E4991B-01A

Information Only Service Note

E4991B Impedance Analyzer, 1 MHz to 500 MHz/1 GHz/3 GHz

E4991B Chassis Assembly and Rear Panel replacement part number change.

Figure 1- 1 New Rear Panel and Chassis Assembly

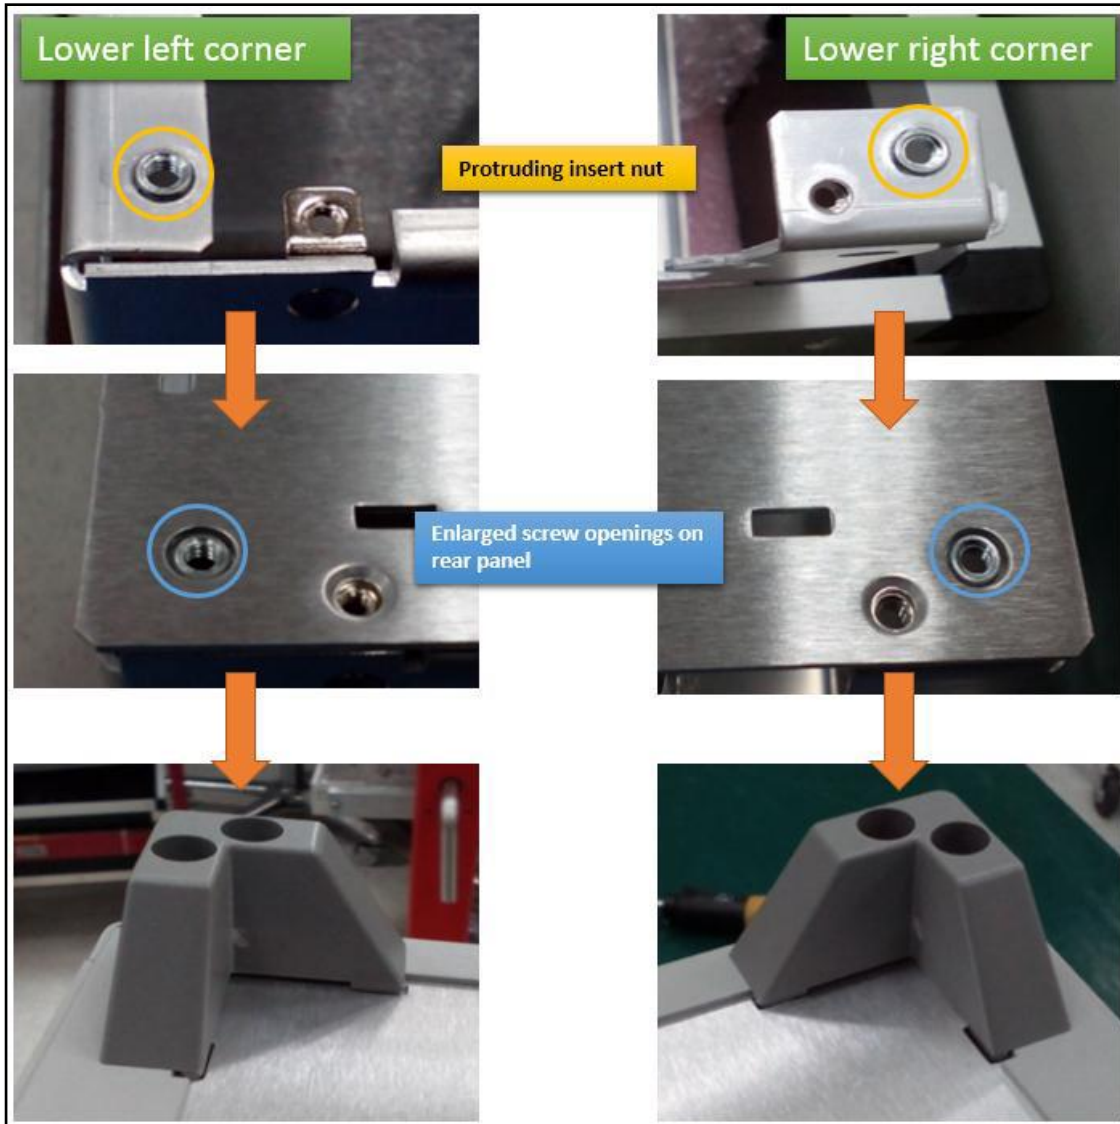
New and improved rear panel and chassis assembly is introduced. Due to mechanical (dimension) change, both rear panel and chassis assembly are required to be replaced with “new” part number on hardware compatibility when either one of the “old” part number is depleted.

The new and improved rear panel and chassis assembly would to further improve the grip between the rear panel and chassis assembly. The insert nut of the chassis assembly is made to be slightly protruded (~1.2mm) resulting in the direct contact (same surface) when the rear panel (~1.2mm in thickness) is installed.

Replace **both** rear panel and chassis assembly whenever one of the following old part is required to be replaced. Shown in Table 1-1 is the replacement part support plan for E4991B. Refer to Figure 1-1 for the detailed illustration on the changes.

Perform full calibration in ensuring the instrument is well within specification since the chassis assembly replacement would require the removal and assembly of analog modules.
